LAKE MENDOTA DRIVE ASSESSMENT DISTRICT - 2023

CONTRACT NO. 8715

**LAKE MENDOTA DRIVE ASSESSMENT DISTRICT - 2023
CONTRACT NO. 8715**

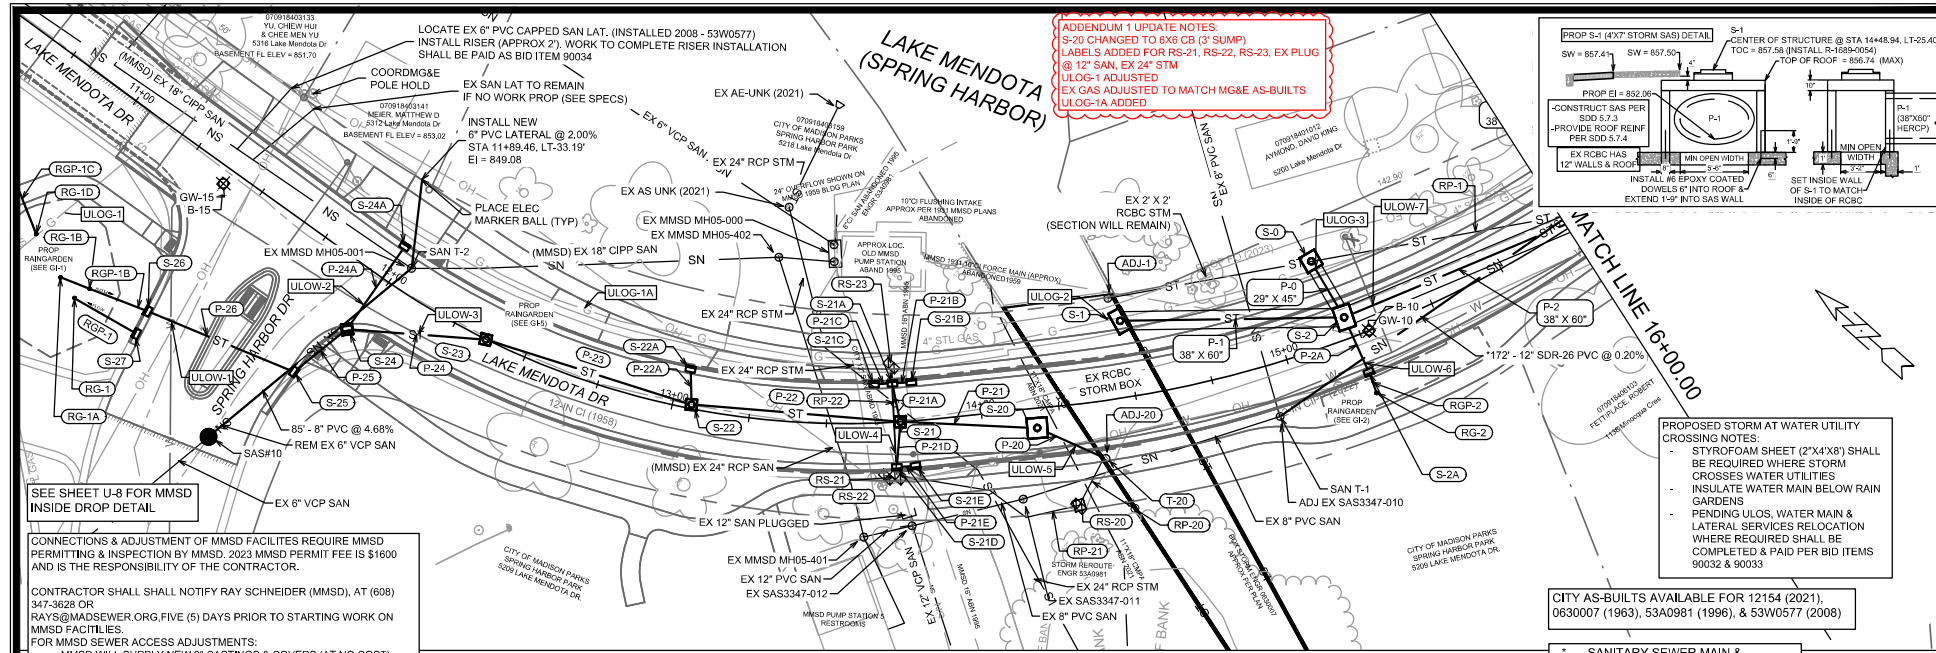
ADDENDUM 1 UPDATE NOTES:
 S-20 CHANGED TO 6X6 CB (3' SUMP)
 LABELS ADDED FOR RS-21, RS-22, RS-23, EX PLUG @ 12\"/>

14082
 U-4

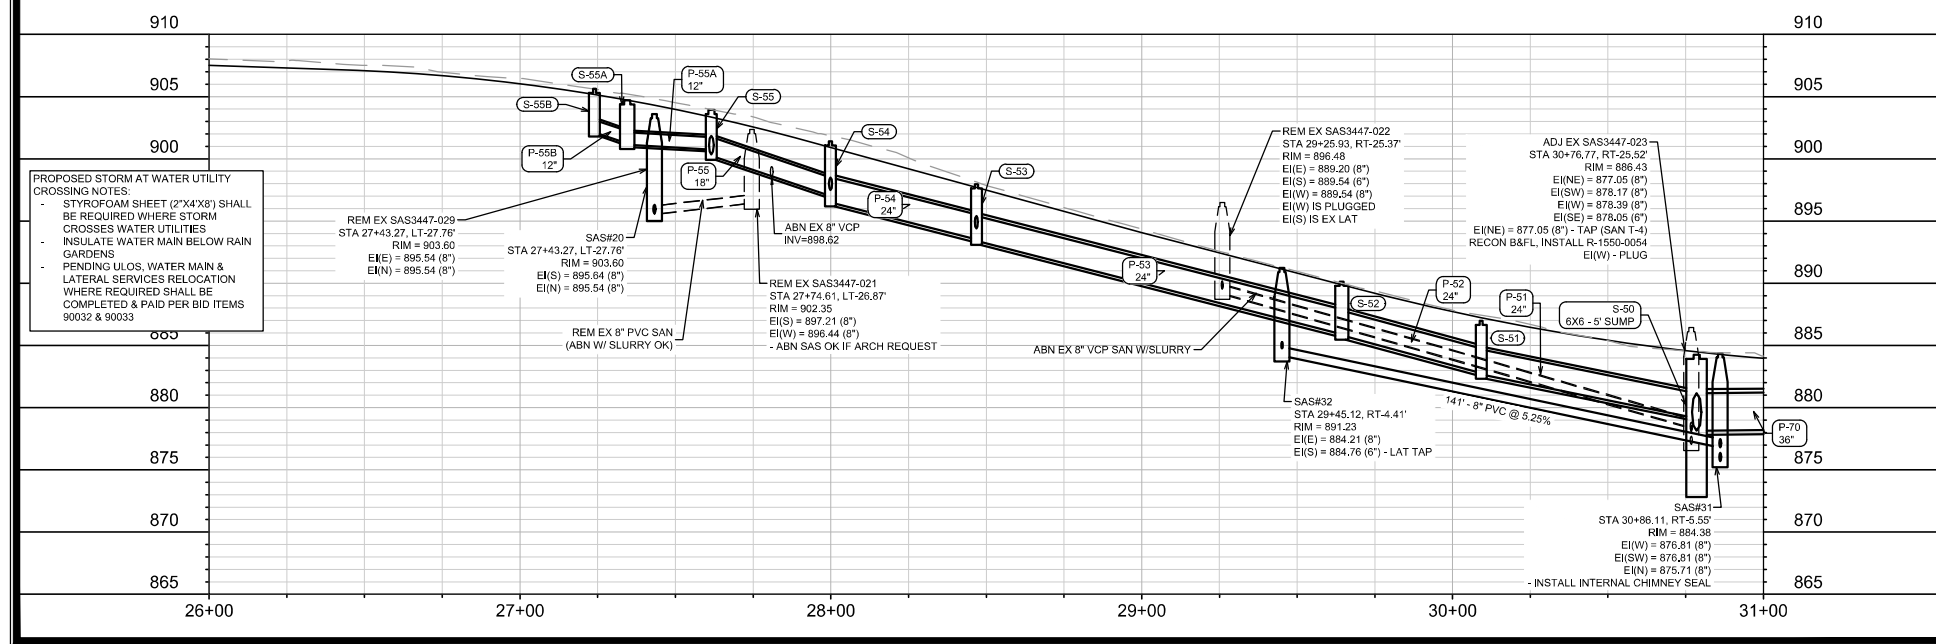
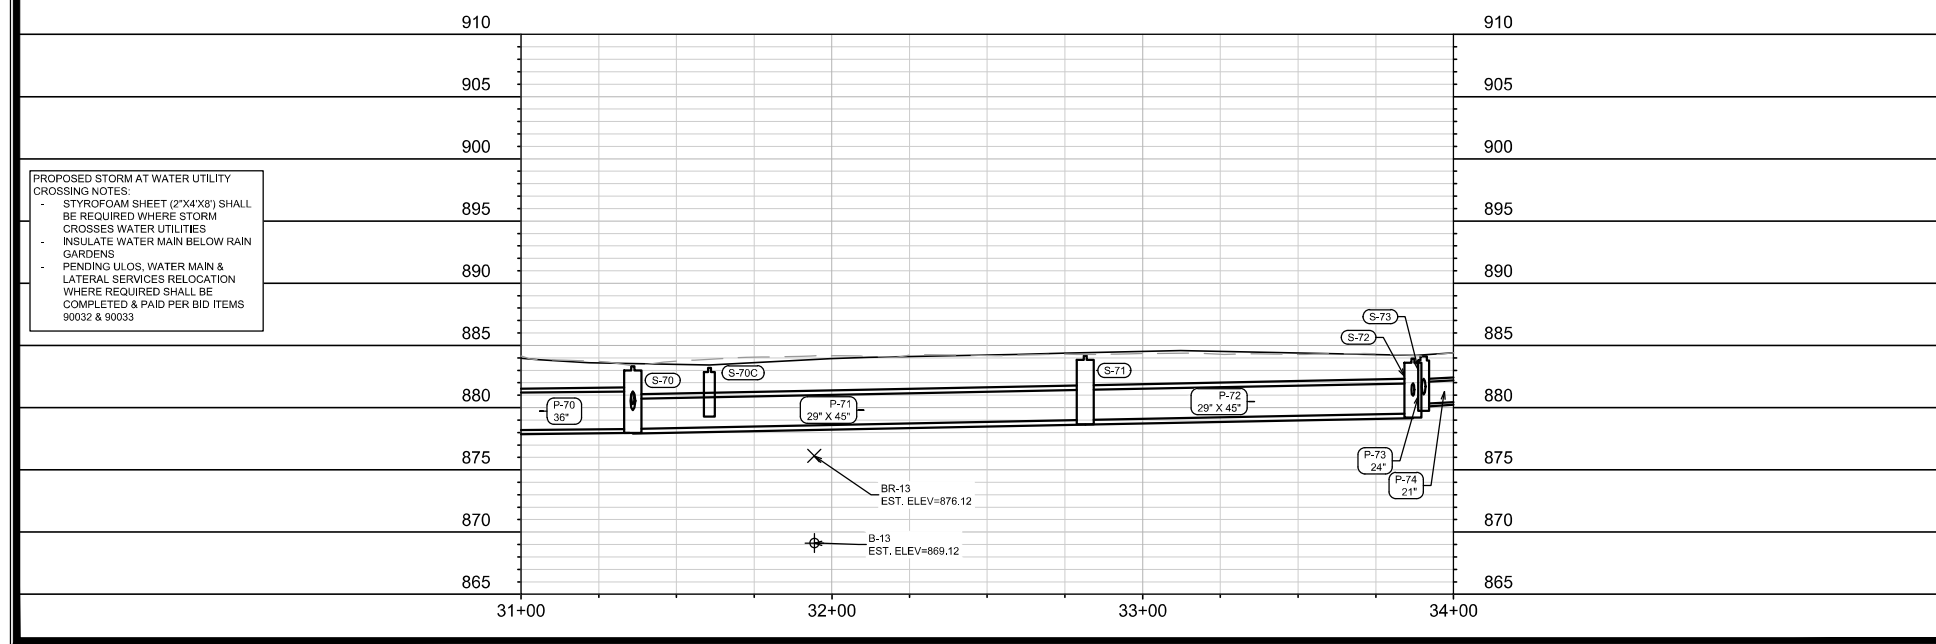
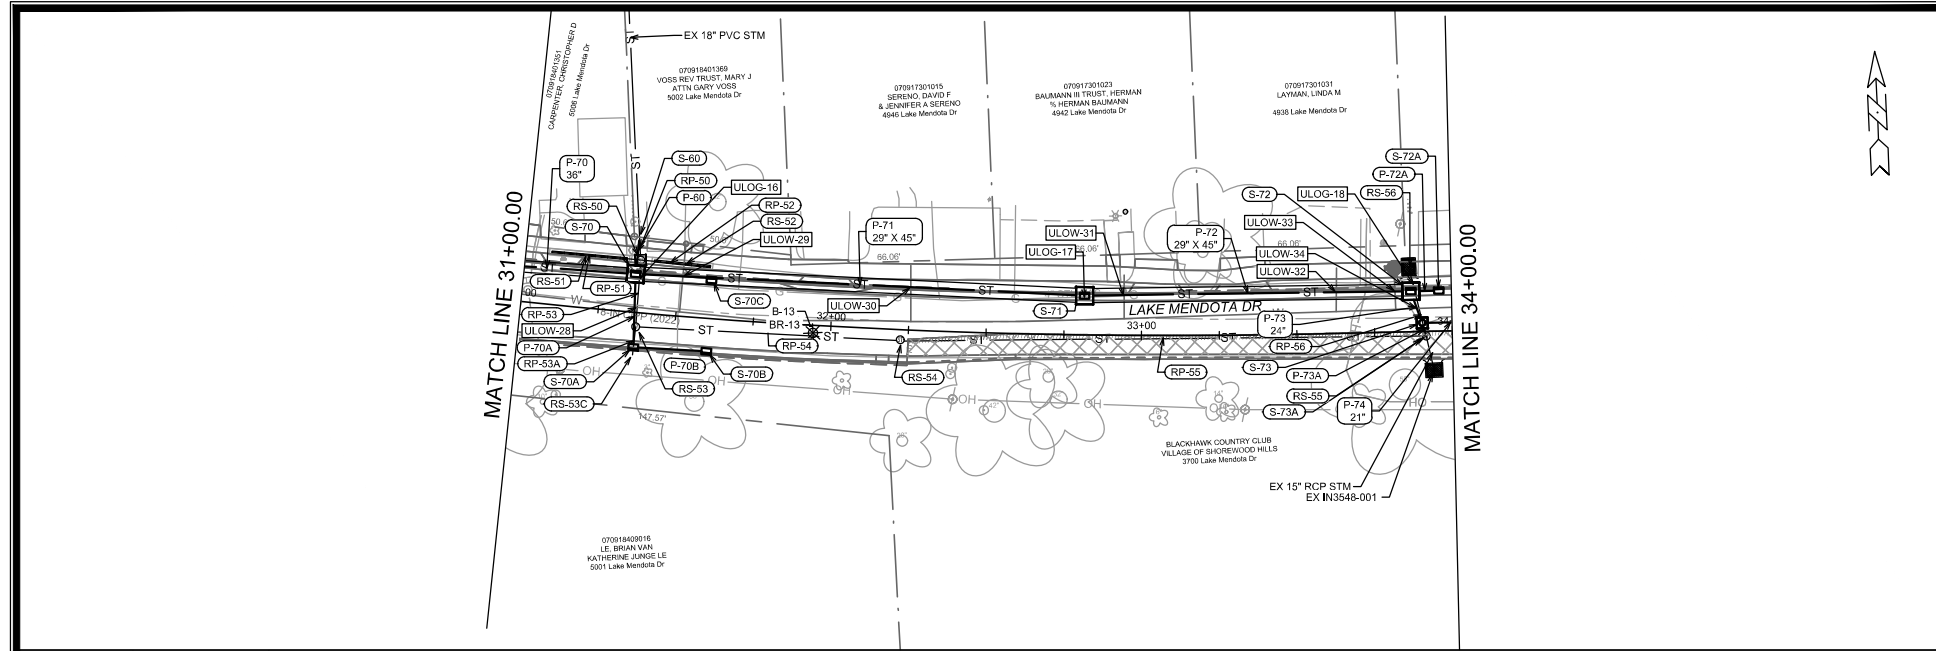
ADDENDUM 1 UPDATE NOTES:
 ADDED SUMP NOTE TO S-50

14082
U-8

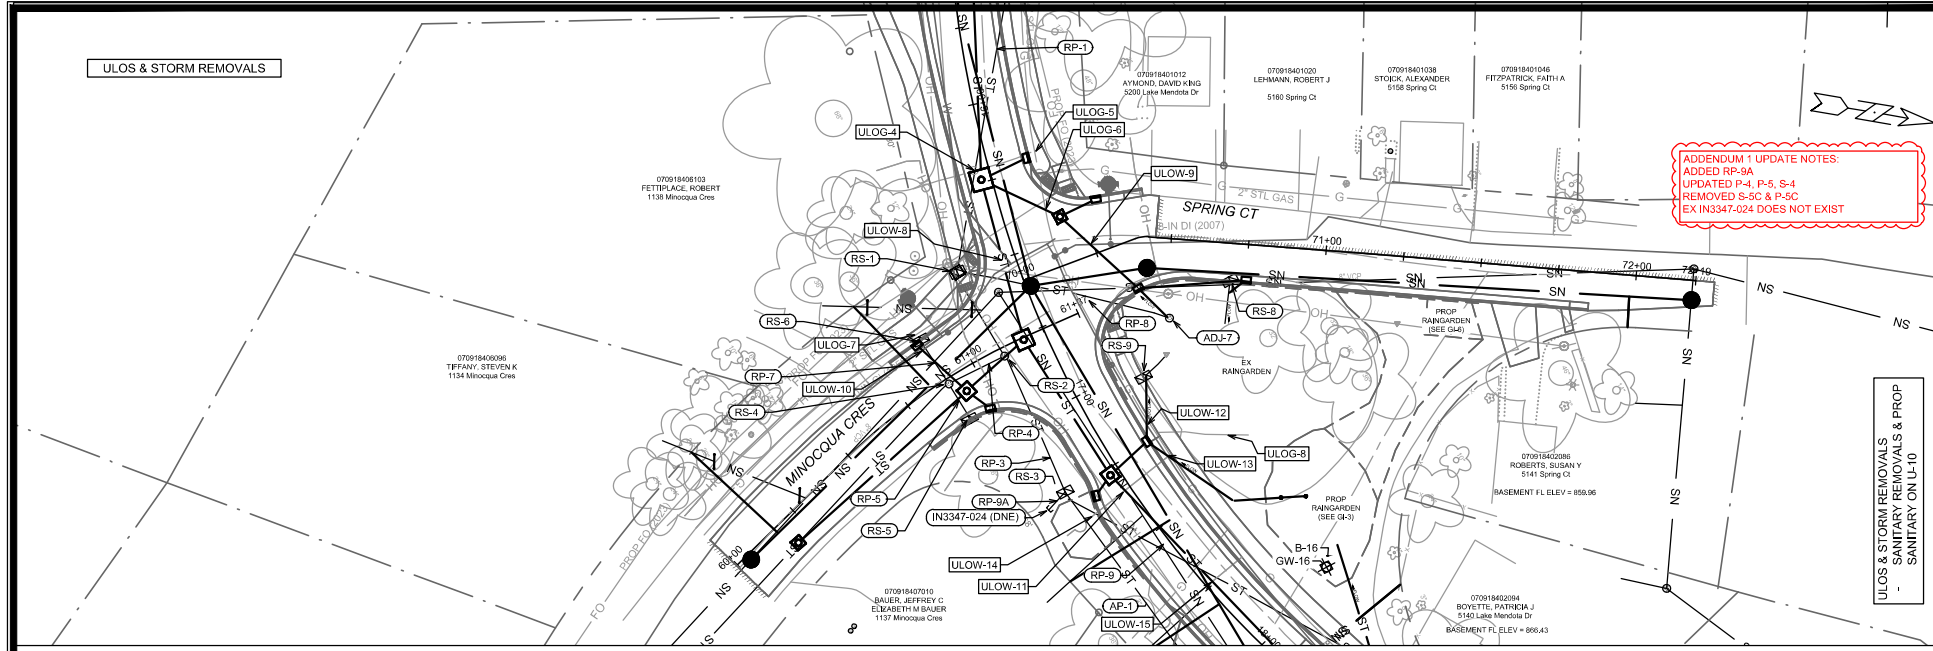
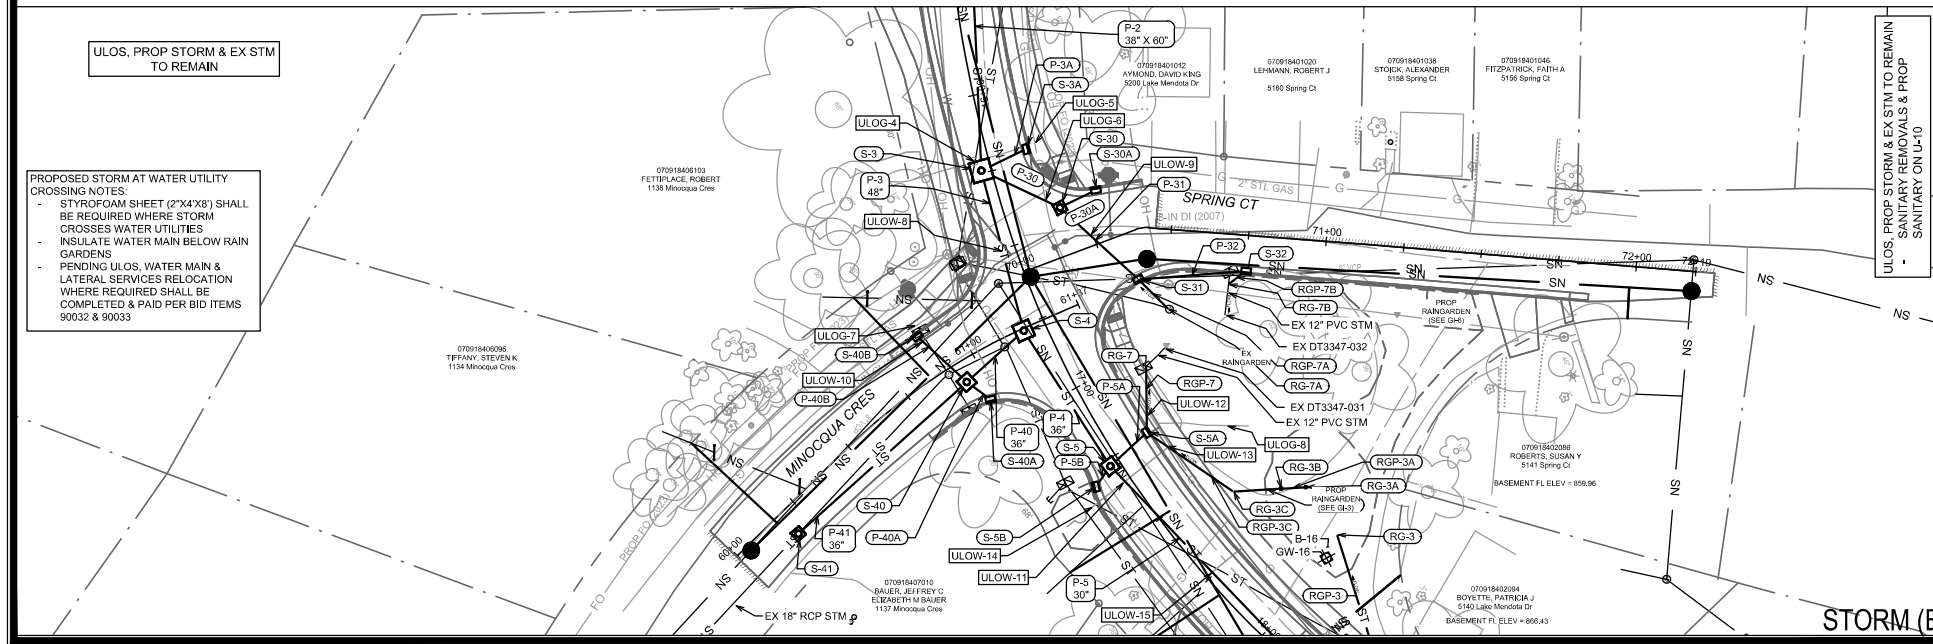
ADDENDUM 1 UPDATE NOTES:
 ADDED RP-8A
 UPDATED P-4, P-5, S-4
 REMOVED S-CC & P-5C
 EX IN3347-024 DOES NOT EXIST

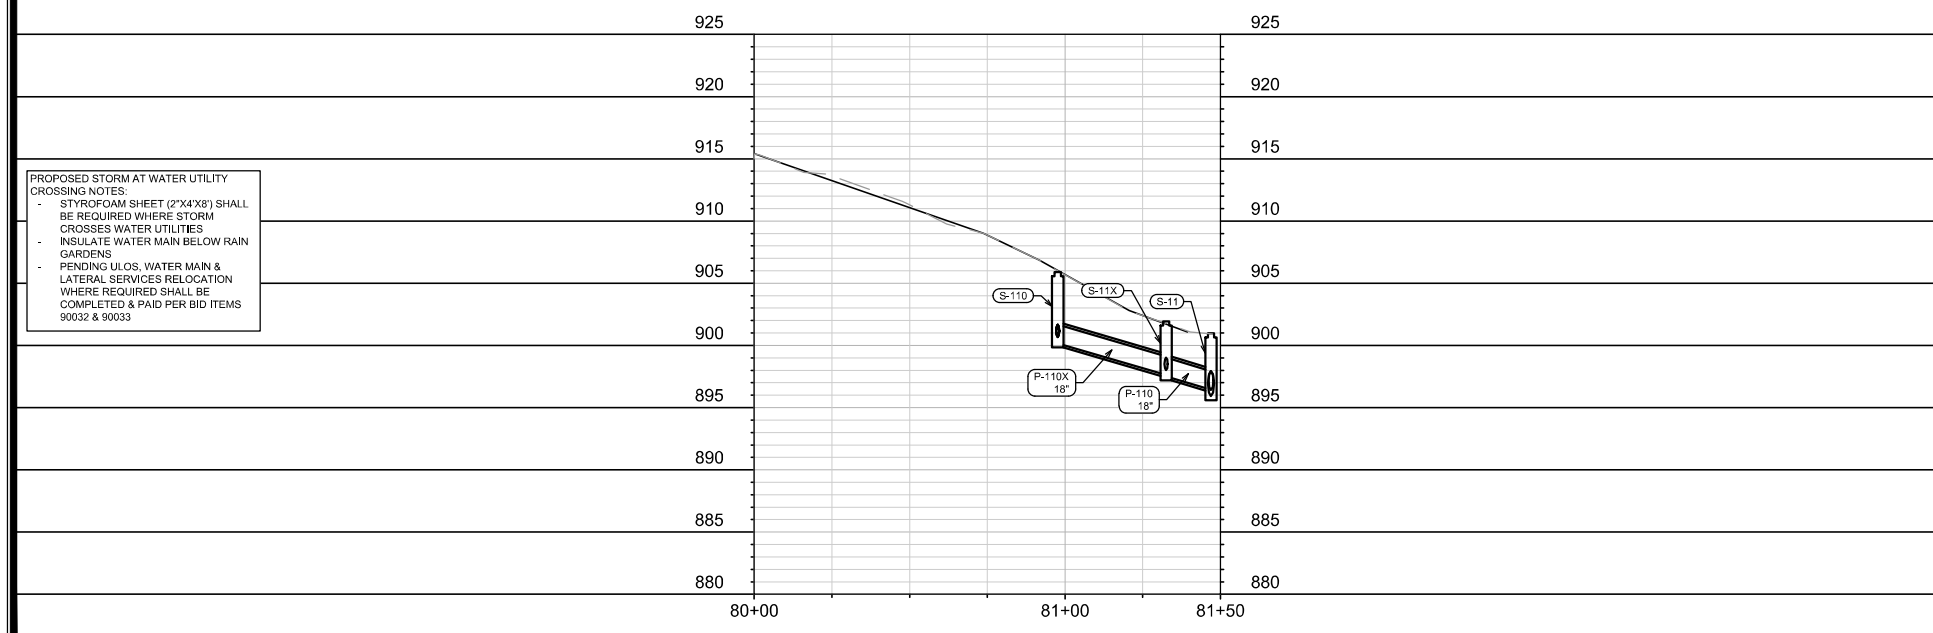
ADDENDUM 1 UPDATE NOTES:
 RS-30 FIELD LOCATED (BURIED)
 RP-30, RS-30, RP-31 & RP-32 UPDATED
